PRODUCT BULLETIN # 20449Generic Copy

Issue Date: 14-Apr-2014**TITLE:** Packing material (band) change for Image Sensor products.**PROPOSED FIRST SHIP DATE:** 15 April 2014

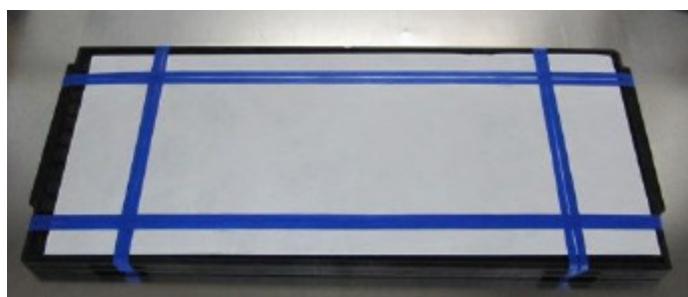
ON Semiconductor's Image Sensor group is optimizing its packing materials. The band which is used to pack trays together will convert from a pink rubber band to a blue polyester band. The trays and boxes remain unchanged.

This picture only intends to show the new blue polyester band. The actual tray, stacking height, depends on the specific product and order but will remain unchanged versus the current specifications..
